CENTRAL COAST COUNCIL

DEVELOPMENT SUPPORT SPECIAL COMMITTEE

# Agenda

8 MAY 2023

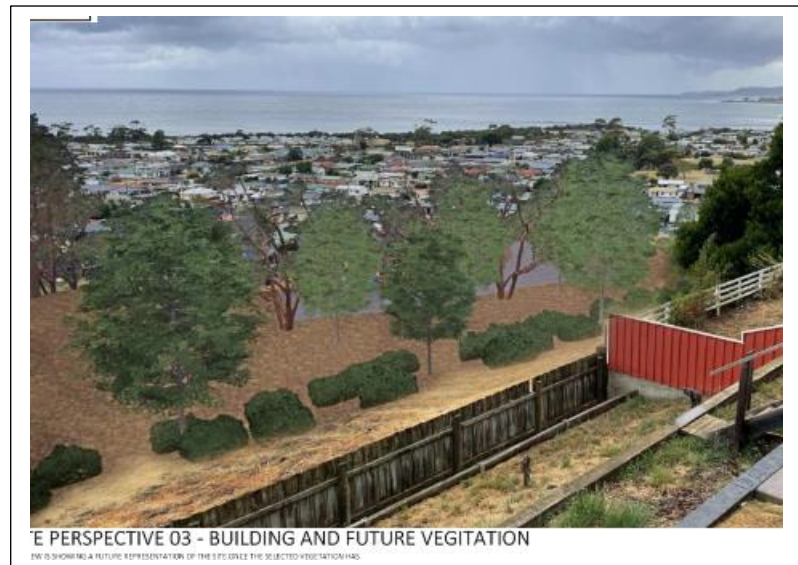
As shown in the site perspective sheet No. 03 (refer to Annexure 2), the proposal would include some selected vegetation to be planted along the southern side of the development site. This would assist with "screening" the proposed single dwelling. It is also considered good hillside practice regarding landslip hazard management.

Refer to image below that shows a “snip-it” of the proposed vegetation screening, as seen in the site perspective image.

To assist in screening and good hillside management, a condition is to be applied to the Planning Permit requiring a landscape plan be submitted for revegetation of the southern

area of the site, detailing the location, species and timing of vegetation to be planted.
